**Fort St. Vrain Nuclear Station  
Decommissioning Project**

**FSV FINAL SURVEY EXPOSURE  
RATE MEASUREMENTS**

May 17, 1996

## RESPONSE TO COMMENTS PROVIDED 3/19/96

FIGURE 3

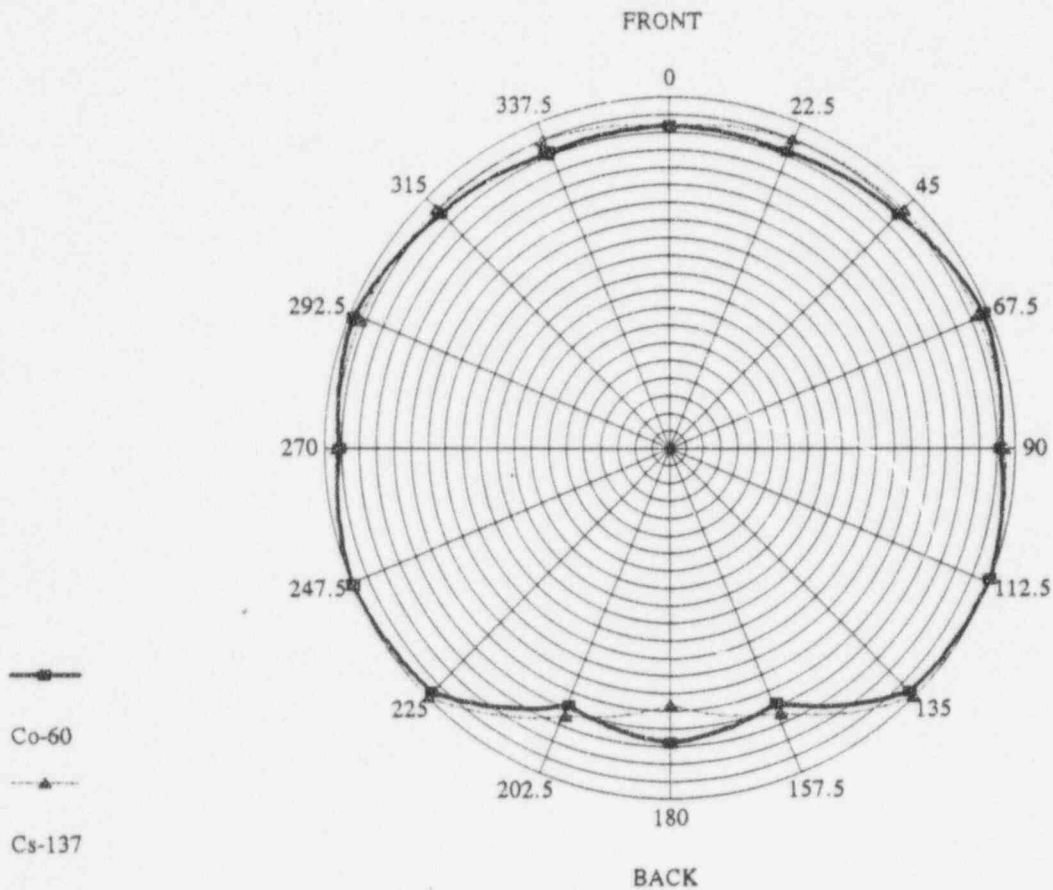
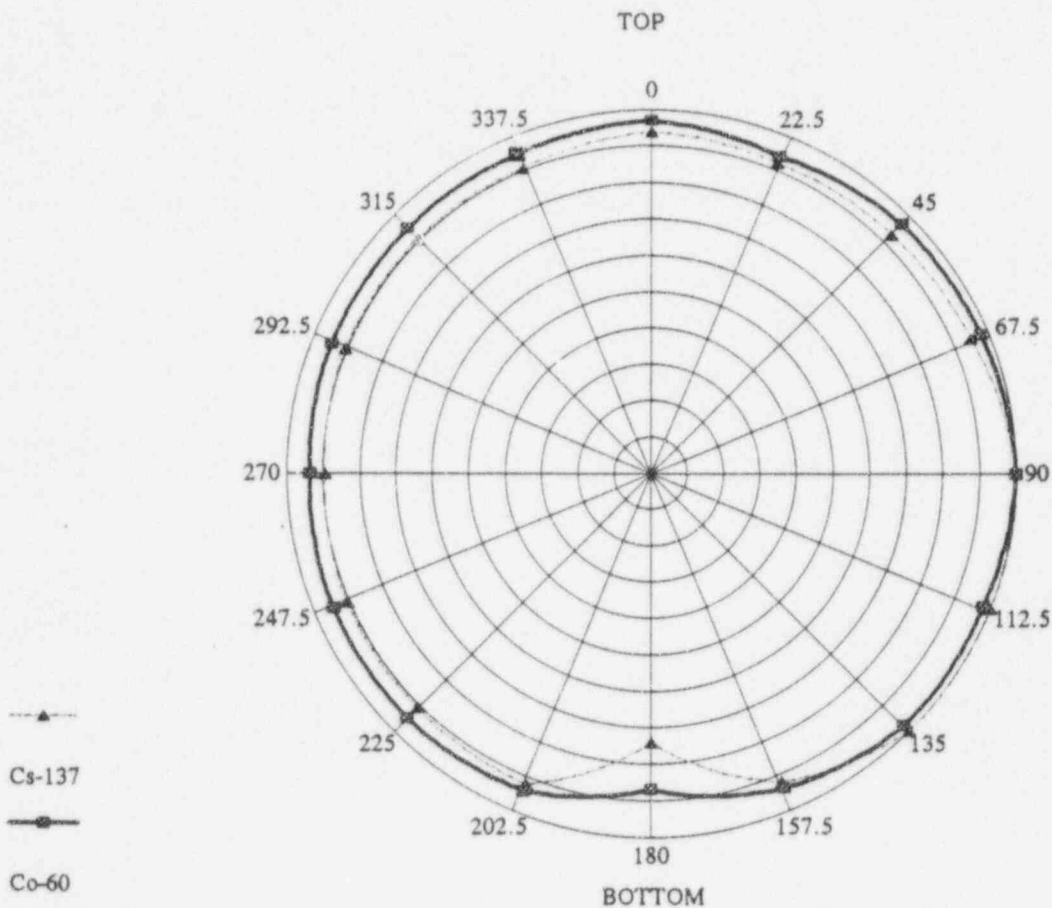
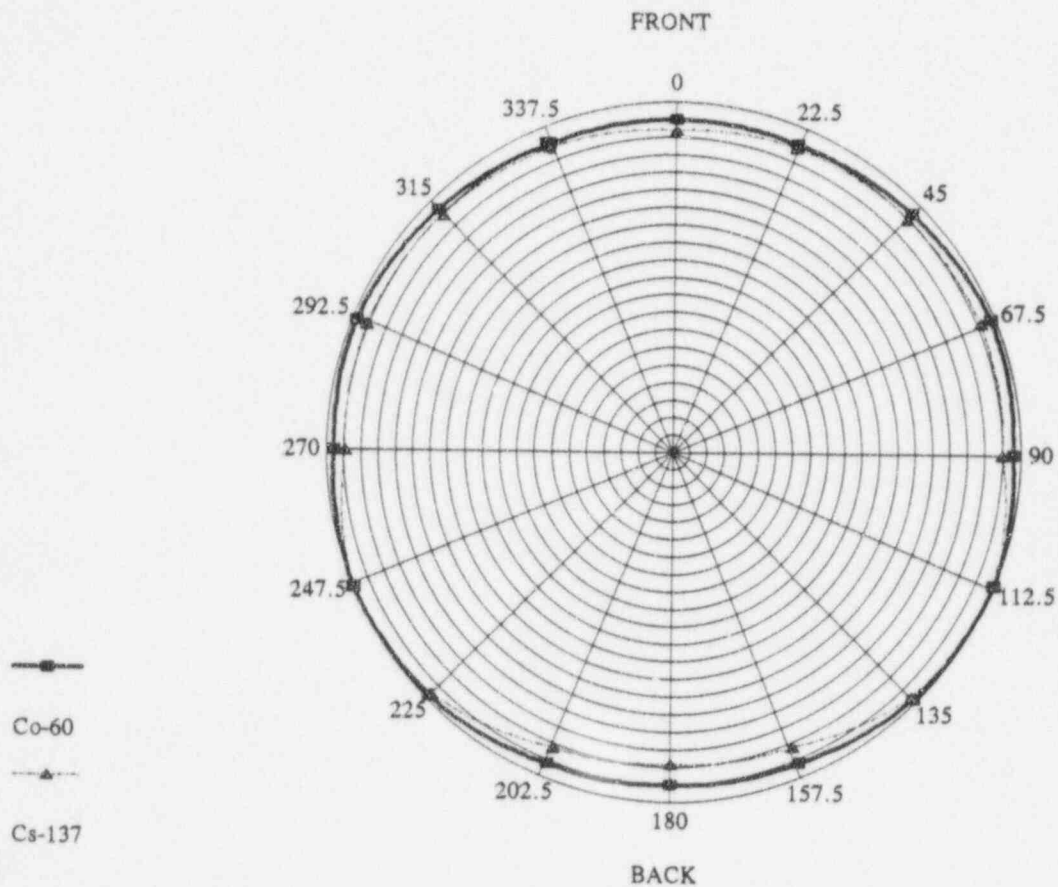
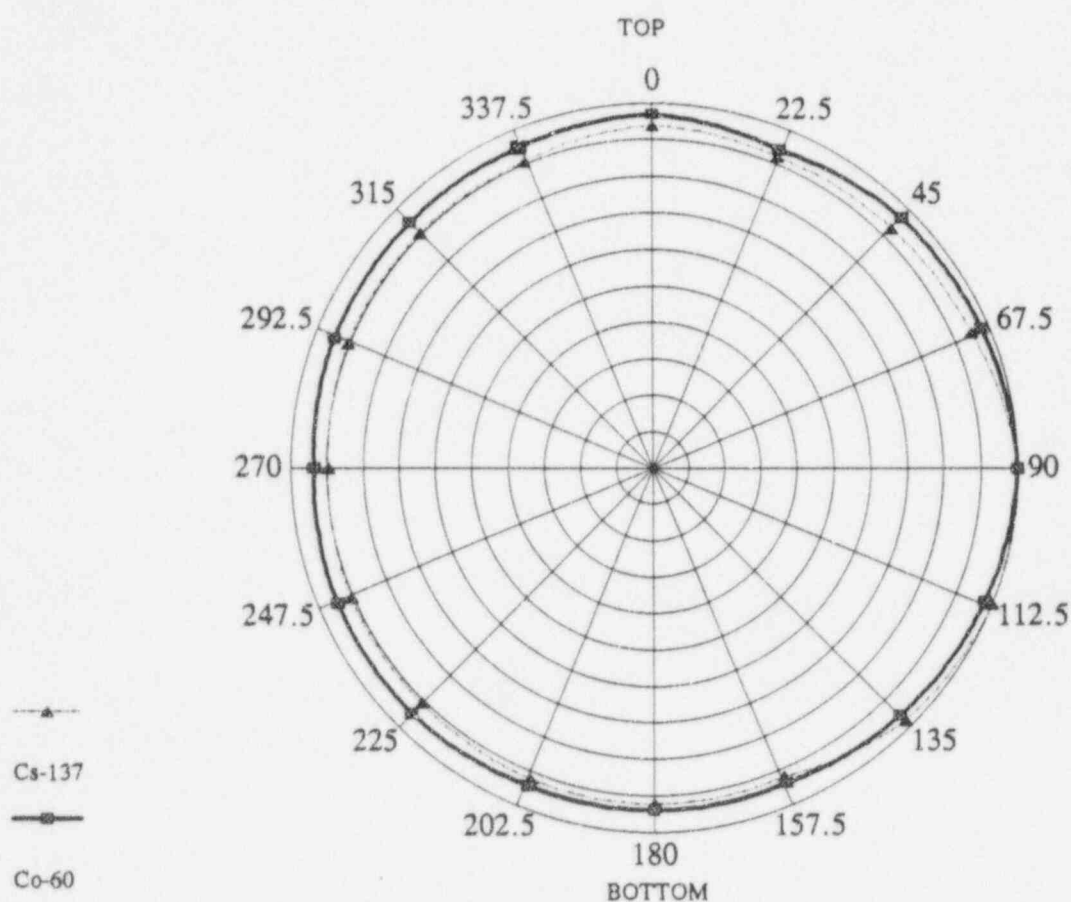
4. **Compare MICROSPEC results with the Pressurized Ion Chamber (PIC). What corrections will be applied to the results obtained with the MICROSPEC to compensate for response differences (MICROSPEC vs. PIC)?**

instruments at various angles of incidence, beginning at 0 degrees (directly in front of the MICROSPEC NaI detector and top center of the PIC) and continuing around the instrument at 22.5 degree increments to a maximum of 337.5 degrees. This was performed initially with a Co-60 source and then repeated with Cs-137. To ensure consistency in comparison of the response of the two instruments, the source was placed at a distance measured from the detector centerline for all measurements. When measuring the source distance for the PIC, the detector centerline was assumed to be the center of the 1 ft<sup>3</sup> outer box.

Measurements were performed at a source distance of 9" from the detector centerline for both instruments and both sources (Figures 3 and 4), then repeated at a distance of 27" (Figures 5 and 6). At the 9" measurement distance, the MICROSPEC response was uniform to an angle of 112.5 degrees, increasing to 135 degrees as the distance was increased to 27". As expected the response decreased as the angle approached 180 degrees. However, when the source distance was increased, the response improved at these angles with a maximum 9% under response for Co-60 and 18% under response for Cs-137 at 180 degrees. The PIC displayed a similar response, uniform to 157.5 degrees, with a maximum under response at 180 degrees. This response also improved as the source distance was increased, with a maximum under response of 7% for Co-60 and 8% for Cs-137 at 180 degrees. It is important to note that 180 degrees on the PIC was found at the location where the steel plate is attached to the box for securing the detector tripod. At most measurement locations this is the angle of interest (source term contributing to exposure rate from underneath the detector). Graphs of the angular response for the PIC and MICROSPEC at both measurement distances are attached.
